PIC32MX534/564/664/764 Family Silicon Errata and Data Sheet Clarification

The PIC32MX534/564/664/764 family devices that you have received conform functionally to the current Device Data Sheet (DS60001156H), except for the anomalies described in this document.

The silicon issues discussed in the following pages are for silicon revisions with the Device and Revision IDs listed in [Table 1](#). The silicon issues are summarized in [Table 2](#).

FIGURE 1: EXTERNAL COMPARATOR SCHEMATIC EXAMPLE

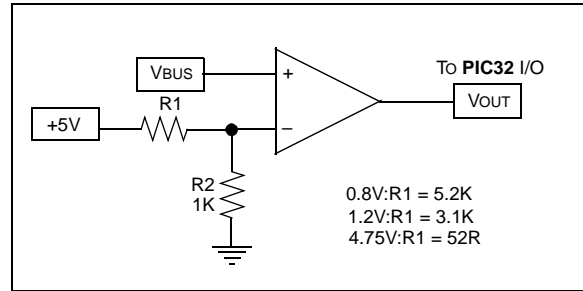
When the USB model is configured for OTG operation, it may not recognize all required OTG voltage levels on VBUS pin.

Use external comparator circuit to detect OTG specific voltage levels on VBUS pin.
